**CURTIS H. STANTON ENERGY CENTER
UNIT 1**

SITE CERTIFICATION APPLICATION

REQUEST FOR MODIFICATION OF CERTIFICATION 1
SUMMARY DESCRIPTION OF CHANGES TO APPLICATION

FIGURE 3.9-6. PROPOSED MODIFIED PIPELINE CORRIDOR AND NEW COUNTY ROAD

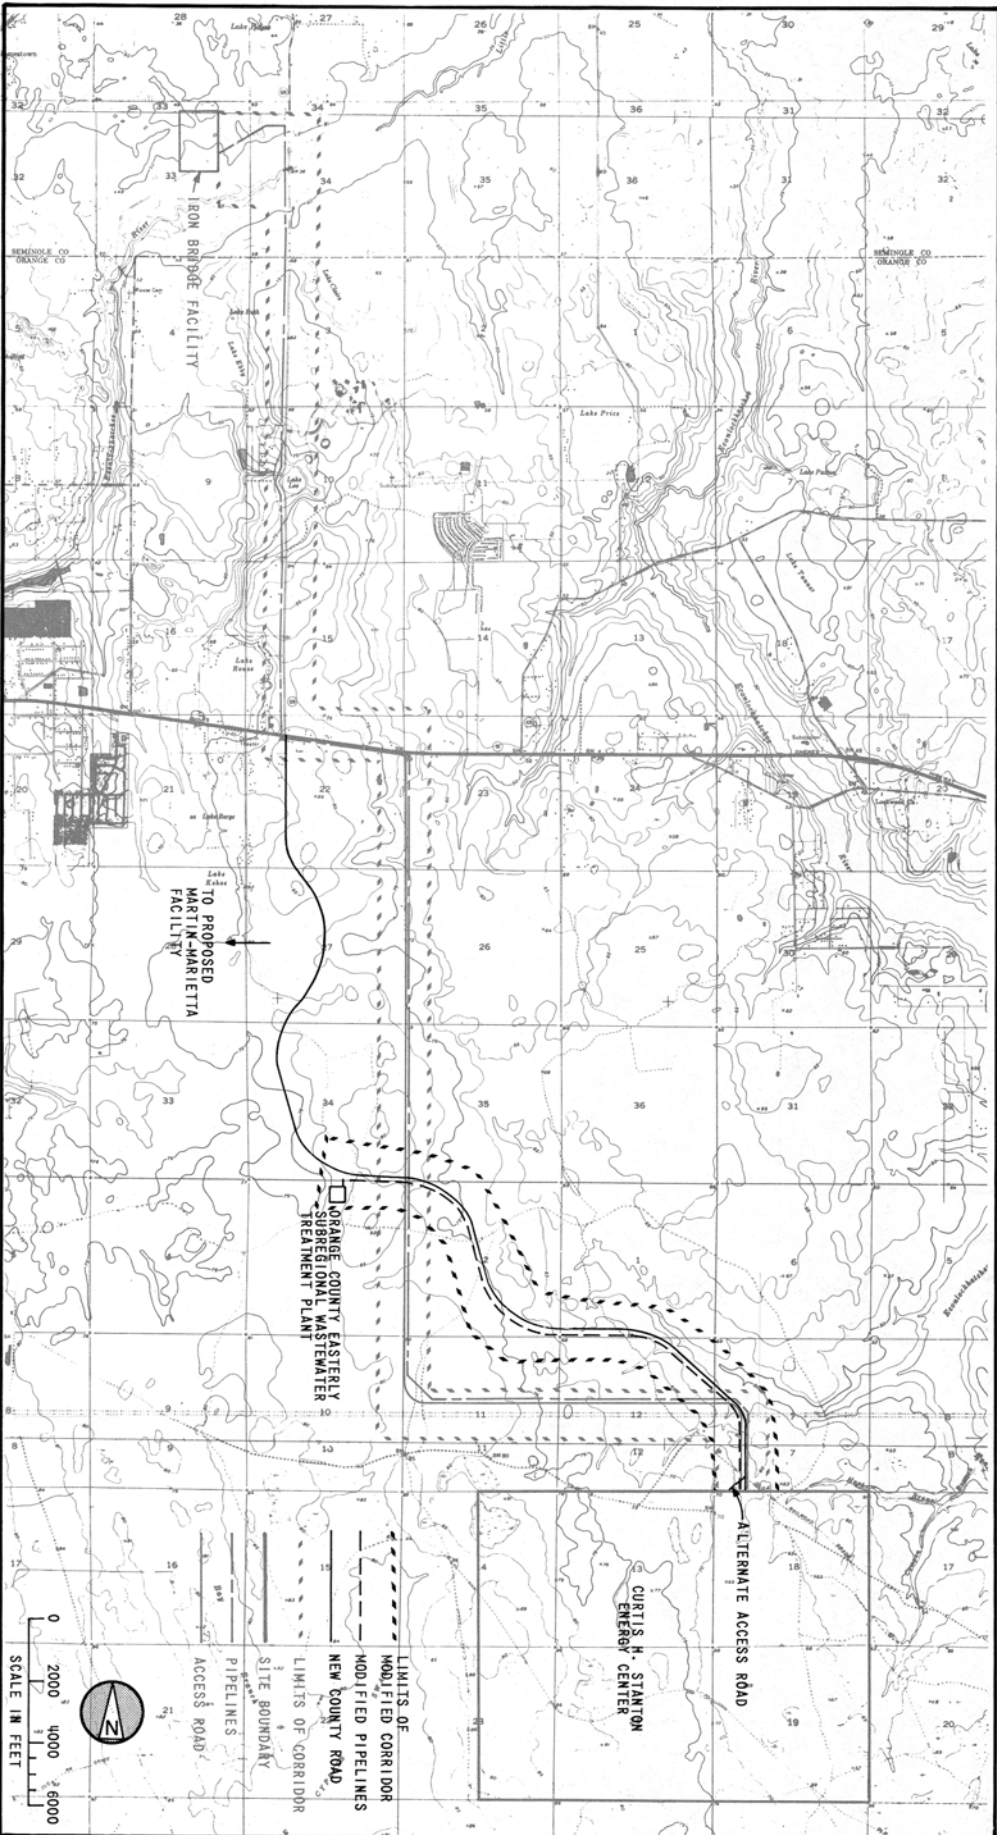
Section 3.9, Subsection 3.9.2, has been changed to reflect that vehicular access to the Stanton Energy Center will be provided by a new Orange County road. The main plant access road shown in the amended application will not be constructed. Figure 3.9-6 has been revised to illustrate the route of the new Orange County road.

- Makeup and Return Water Pipelines. Section 2.2, Subsection 2.2.2.1, Section 2.5, Subsection 2.5.16, and Section 3.9, Subsection 3.9.1, have been modified to show a new and shorter pipeline route which is a result of the new Orange County road and the change in the source of cooling water makeup. Figure 3.9-6 has been revised to

show the modified pipeline route in relation to the new Orange County road and the Orange County Plant. Section 2.7, Subsections 2.7.7.7, 2.7.7.8, and 2.7.7.9 have been deleted and Figure 2.7-9 has been deleted. Subsection 2.7.8 has been revised to delete references to Figure 2.7-9.
